HIGHLIGHTED AA 2024 AREAS

la serena senior apartments
457 coors blvd. nw
albuquerque, new mexico 87121

revised permit set

a3.11

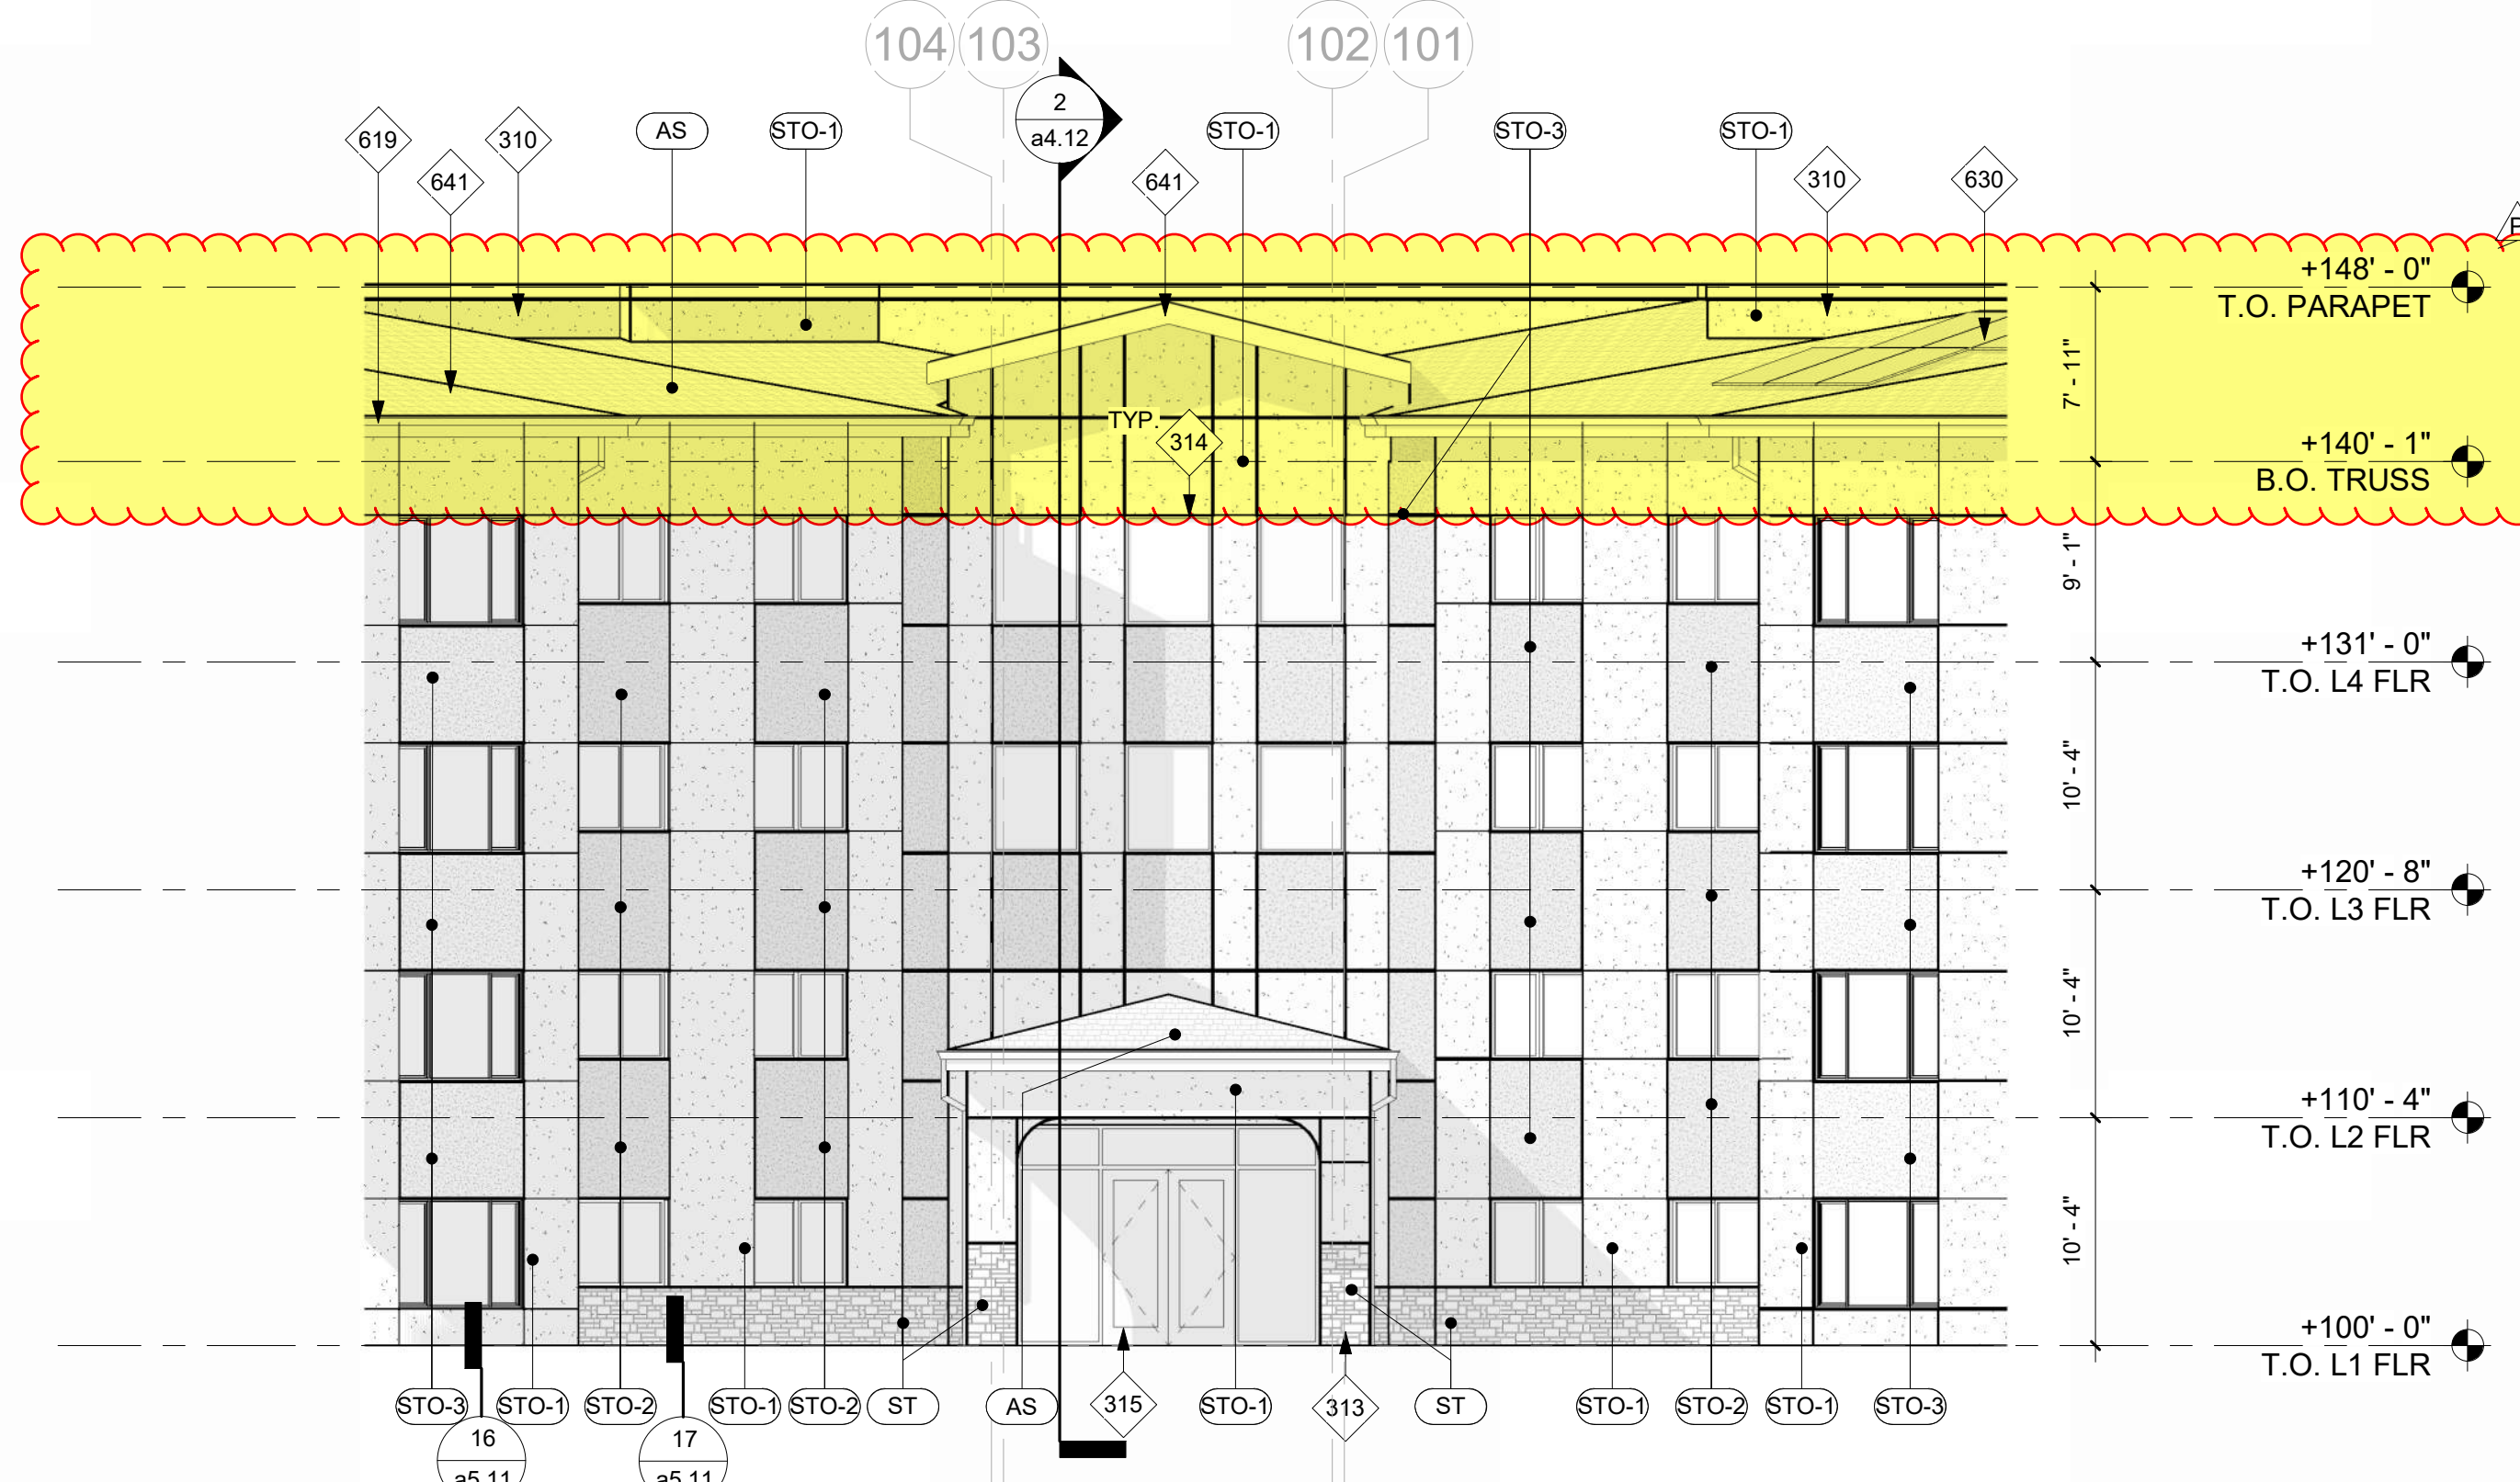
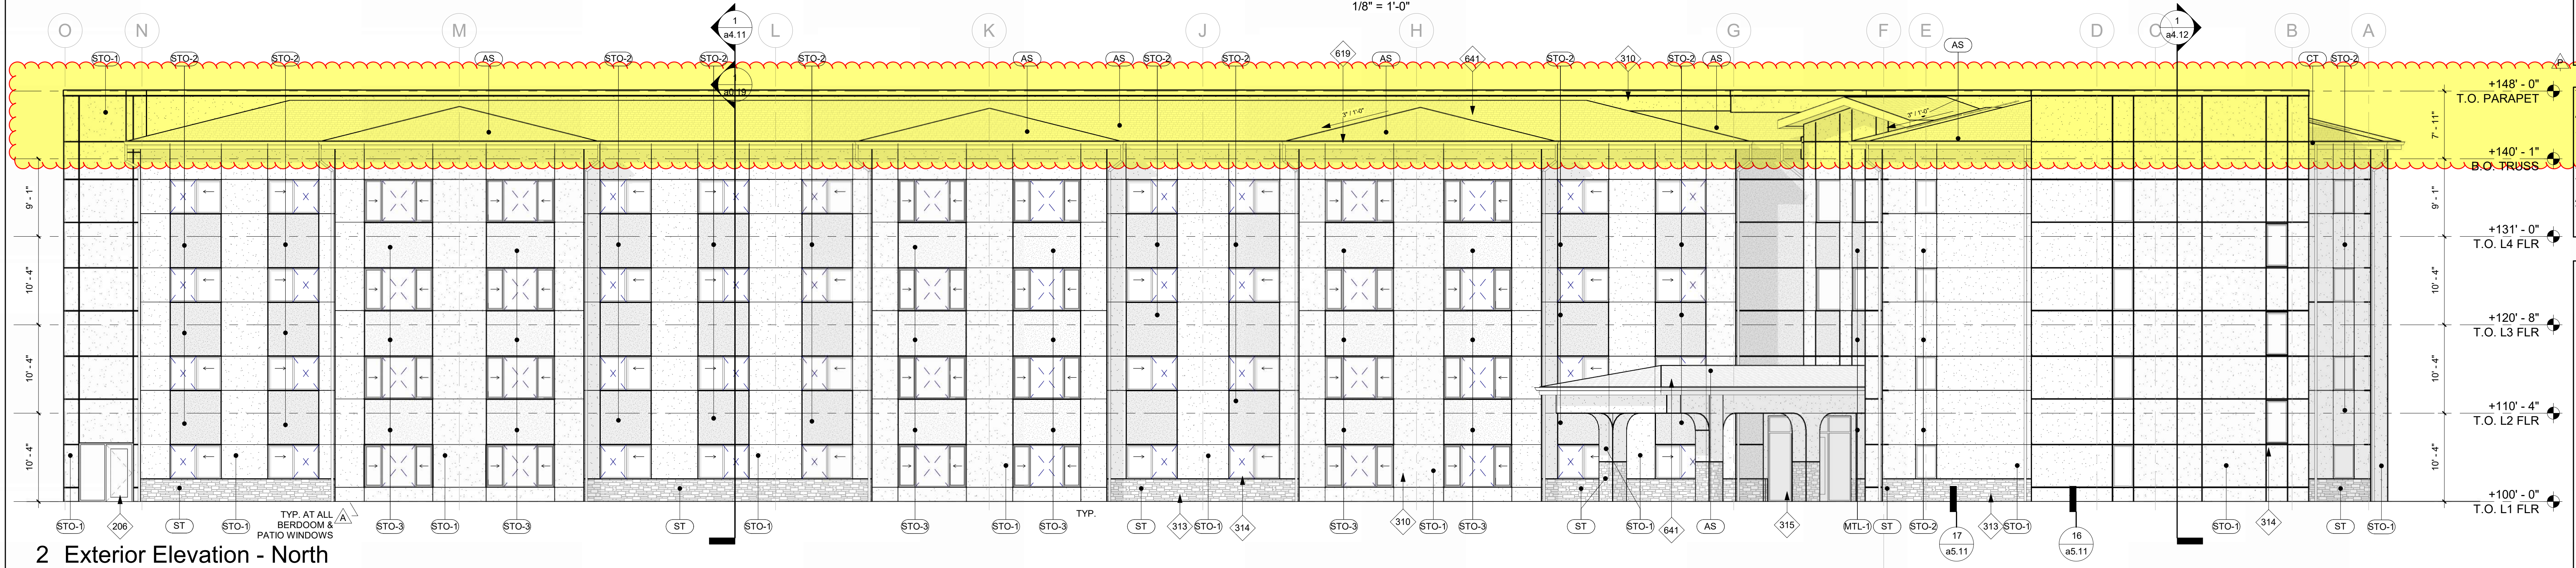
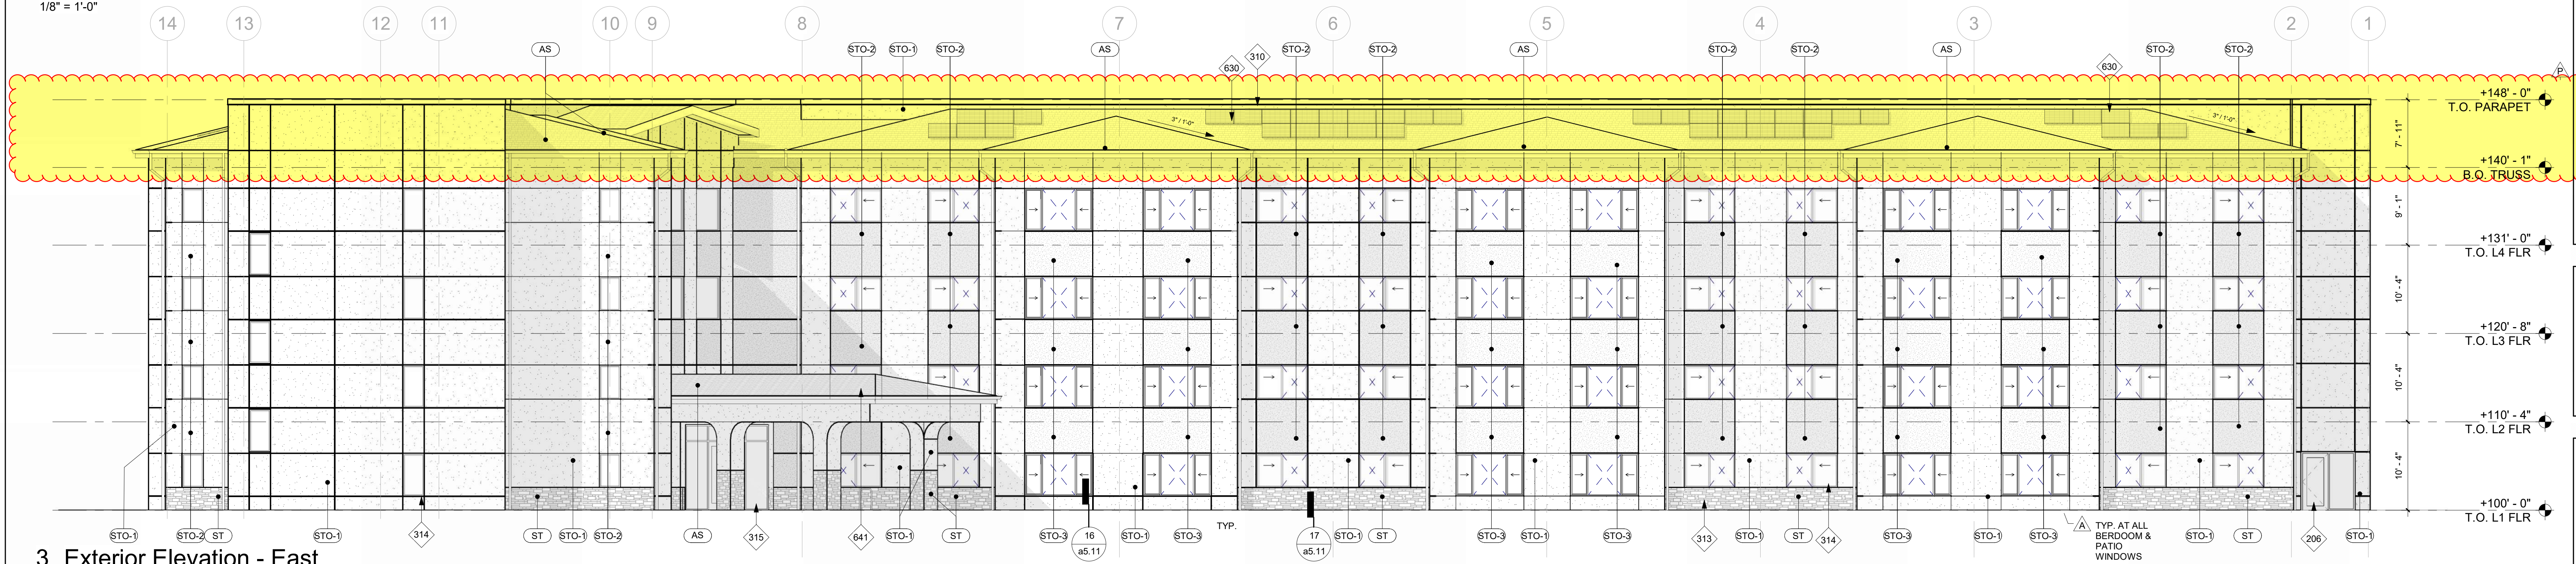
- 1.) Roof and parapet heights raised. Parapets now at 148'-0"
- 2.) Center "knuckle" of building roof removed in lieu of a parapet design
- 3.) Revised roof design at front entry parapet center "knuckle"
- 4.) Second trellis element added at rear patio parapet of center "knuckle"
